*Addendum to*  
**MC68450**  
**Direct Memory Access Controller**

The following information applies to ADI1216, *MC68450 Direct Memory Access Controller (DMAC) Advance Information Data Sheet for the A84G Mask only*:

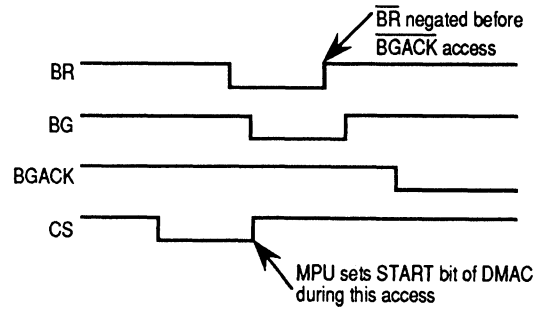
4. When the MPU sets the START bit of the DMAC and a different channel is already active in the limited rate auto-request mode (LRAR), then the following bus arbitration timing may occur:

This timing diagram shows that the  $\overline{BR}$  is negated too early and may cause a bus contention between the MPU and DMAC. The problem occurs in the following conditions:

- Two or more channel are in operation.
- One of the channels is in the LRAR.
- The priority level of the LRAR channel is higher than or equal to the other channels.
- The LRAR channel is initiated before the other channels.

Suggested countermeasures are as follows:

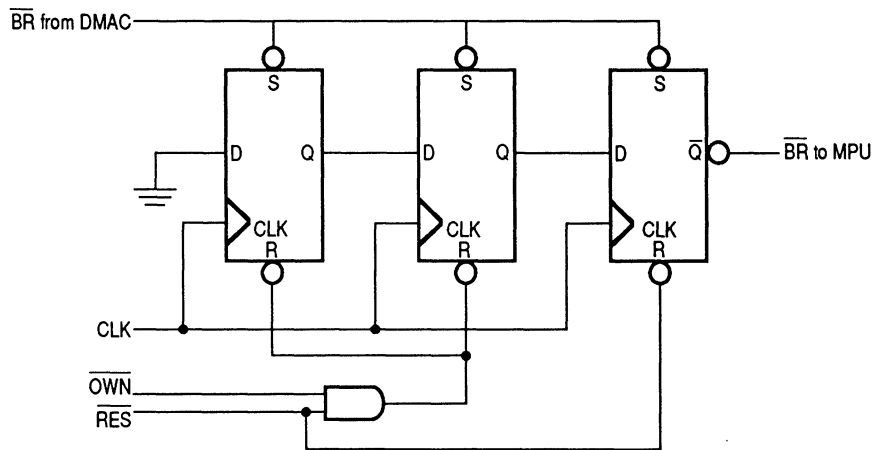
- Set the priority of the LRAR channel to the lowest level. If two or more channels are set to LRAR, a lower priority channel should be initiated first.
- External latches should be provided for as shown in the following diagram:
